Cushman Park

Town of Fairhaven ADA Transition Plan

November 2024

Institute for Human Centered Design

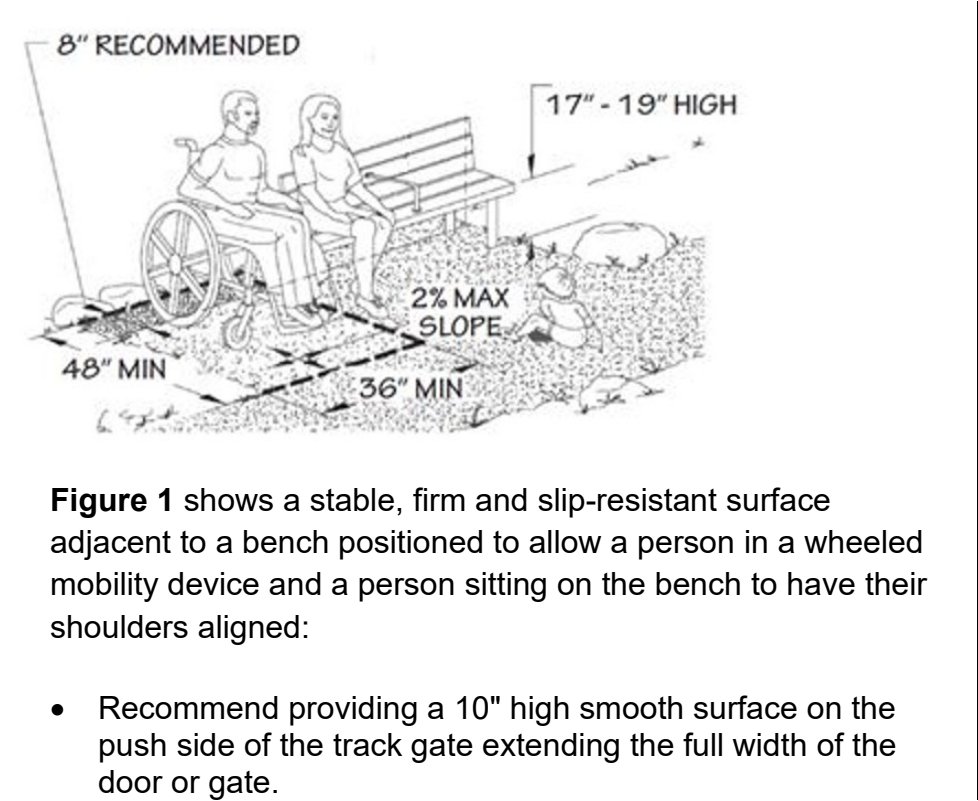
- Recommend providing path lighting on the route from the parking lot to the park.
- Recommend repairing or replacing the gate to the track to make it easier to open. Ensure that it is kept in operable working condition.
- Recommend providing a 36” min. by 48” min. stable, firm and slip-resistant surface adjacent to at least one of the existing benches in each unique program area in the park in a manner that is substantially similar to what is shown in Figure 1.
